Access Compliance Report Public Rights-of-Way (Curb Ramps)

Intersection ID: 12192 Main Street: KILBORNE DR Cross Street: WINDHAM PL Location: N ADA ID: F6FA1EDB0C3E Ramp Type: BlendTrans2 Initial Pass/Fail: Fail **Overall Compliance: No Severity Score:** 10

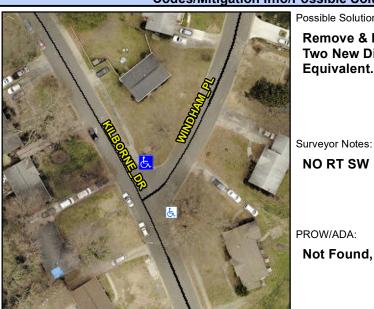
WINDHAM PL Street 1 Name Stop Condition-Street 1 StopSign Street 2 Name N/A Stop Condition-Street 2 N/A Possible Solutions: Remove & Replace Curb Ramp With Two New Directional Ramps or Equivalent.

Not Found, R304.5.1, R304.5.3
